Combroke Parish Council

Consultation for Application 19/00361/FUL

At: The Little House, Combrook, CV35 9HP

Proposed: Enlargement of parking area, erection of retaining wall

Retaining Wall

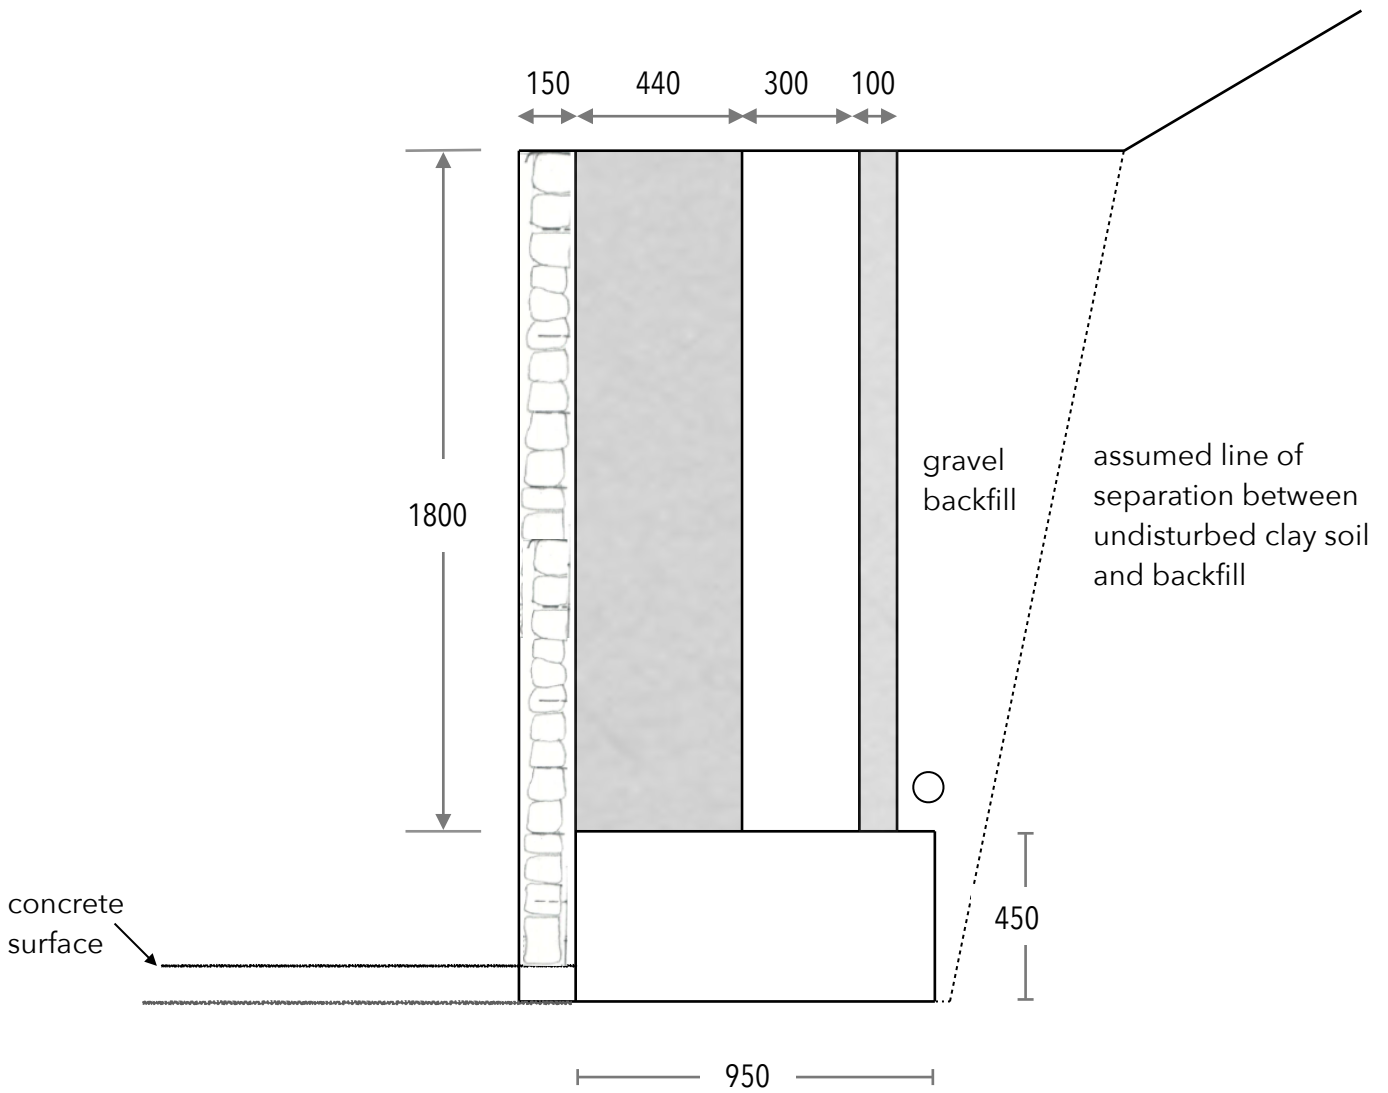
- 3.2. Both the amended drawing 412 42 RevA and the sketch included with the structural engineer’s calculations continue to show the top of the base of the retaining wall to be level with the top surface of the parking area implying that the base of the wall is a foundation below ground level.

- 3.3. This is NOT the case as has been shown previously in photographs and is still evident where stone cladding has not been fixed to the wall. The surface of the parking area is some 300 -350 mm below the height shown and the base of the wall is built directly on the top of the excavated surface which is now known to be clay as discovered by the builders in November 2018 and revealed in the Agent’s letter.

- 3.4. However, closer analysis of the design calculations reveals that the structural engineer has not relied on any part of the wall being below ground and contrary to her original statement that “The wall retains 1.6m height of garden” has acknowledged that the whole height of the wall (2.25m) is retaining the ground behind.

In view of these issues the Parish Council is not convinced that the retaining wall as proposed and constructed has been demonstrated to be safe and requests that further analysis is undertaken and the appropriate remediation is proposed.

Retaining Wall - Forces

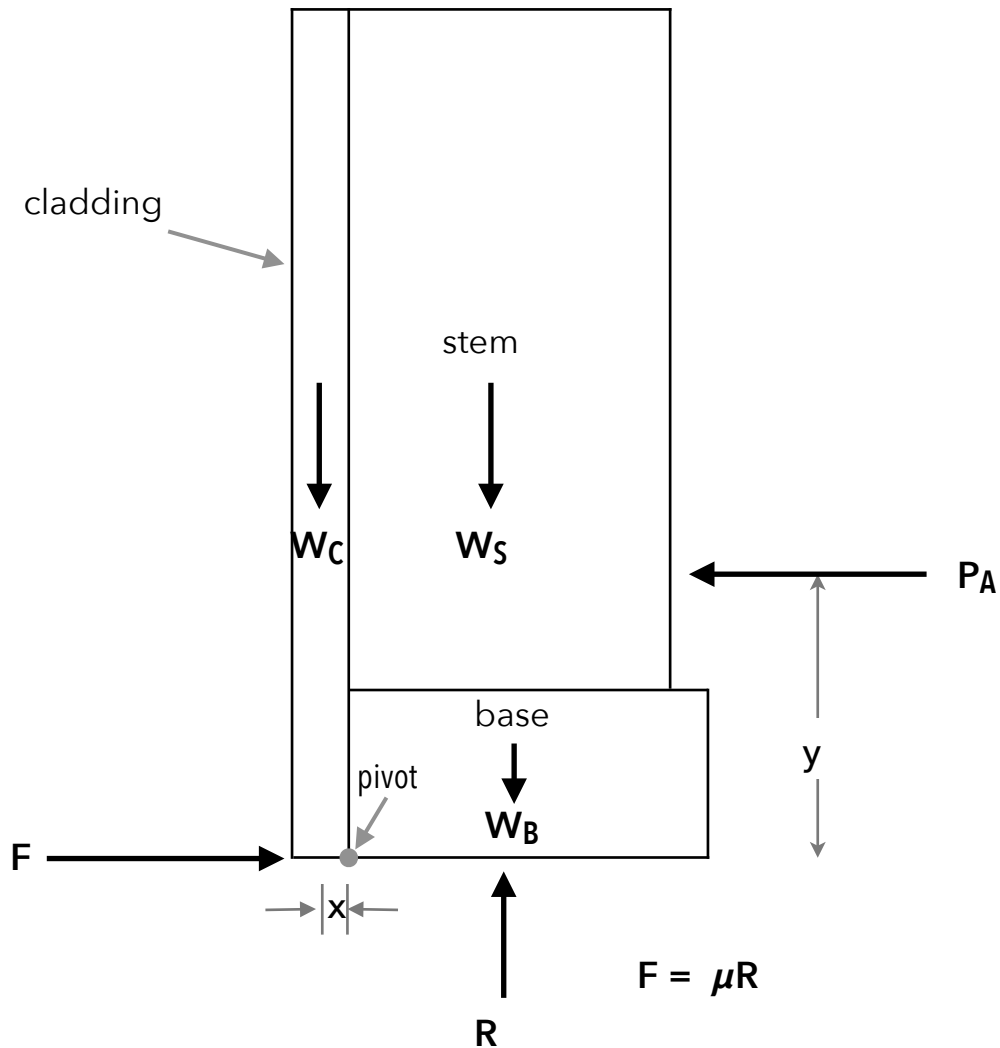
- ➡ The weight of the 150mm thick natural stone cladding added to the front face of the wall is not taken into account in any calculations. The fact that there is no toe to the base of the wall means that the cladding contributes an overturning moment that must be added to lateral forces arising from the active pressure from the retained soil . If all other figures proposed by the structural engineer are used, the additional consideration of the cladding alone results in a revised factor of safety of 1.89 which is a FAIL if the generally accepted minimum value of 2 is used.(See Appendix 1)

- ➡ The calculation presented to test resistance to sliding identifies an incorrect value for friction, and then fails to use it. The equation as presented simply compares a horizontal force with a vertical force. The value of friction presented is the internal friction angle of the soil. The soil has been found to be clay so the “worst case scenario” is actually the true scenario and the value that must be used is the coefficient of sliding friction between the underside of the cast concrete base and the clay soil. A typical value for this pair of materials is 0.3 (Ref. StructX.com). Again using all other figures proposed by the structural engineer, but accounting for the additional weight of the stone cladding which helpfully provides an *increase* in the friction force opposing sliding, the factor of safety is only 1.22 which is a FAIL using the accepted criterion. (See Appendix 1)

- ➡ The calculation of lateral earth pressure acting on the wall assumes that soil is in direct contact with the wall. But the sketch shows gravel backfill which must be present in significant quantity to provide the necessary drainage route into the land drain. Without knowledge of the backfill profile, or the slope being retained, it is unclear how this figure is justified.

Downward load **must** include weight of cladding in addition to weight of stem and base

$$= 1.22 < 2 \quad \text{therefore is a **FAIL**}$$

However the cladding provides a moment about the pivot point tending to overturn the wall.

$$\begin{aligned}\text{Factor of safety} &= \frac{\text{overturning moment}}{\text{restoring moment}} \\ &= \frac{20.14}{10.66} \\ &= 1.89 < 2 \text{ therefore is a } \mathbf{FAIL}\end{aligned}$$

Appendix 2

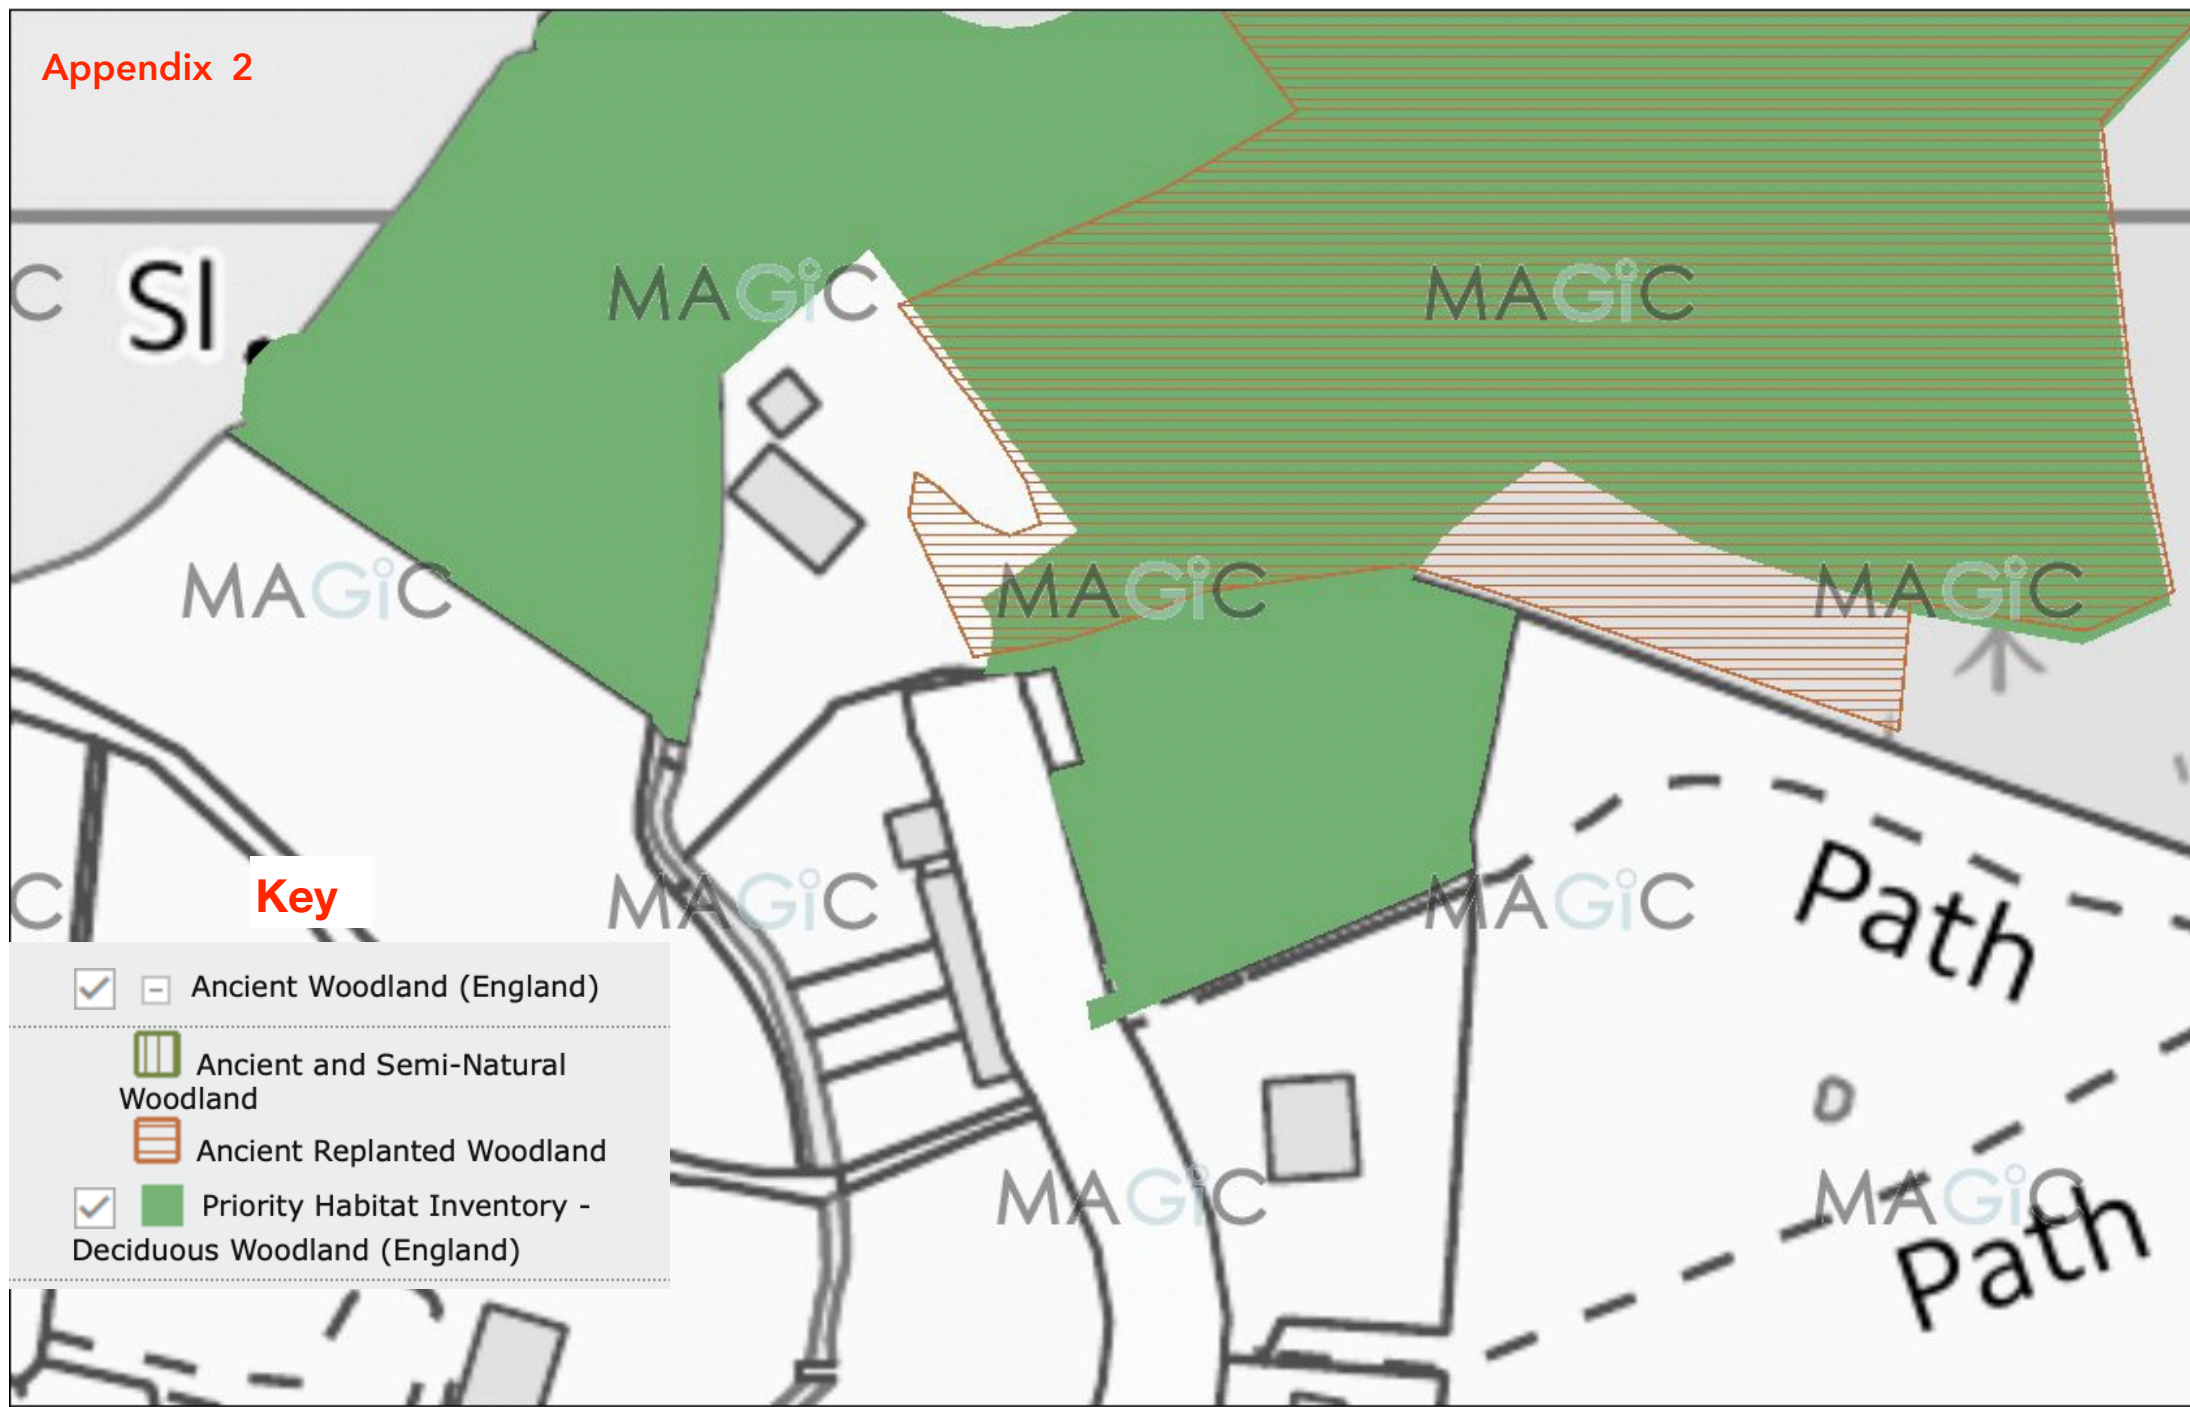
- 5.2. The letter received from the Woodland Trust as a consultee identifies the area adjacent to the site to the north to be ancient woodland. The map (copy attached Appendix 2) taken from www.magic.defra.gov.uk shows that the retaining wall lies within 3 - 4 metres of the ancient woodland and that one of the trees harmed by the excavations was part of the ancient woodland.
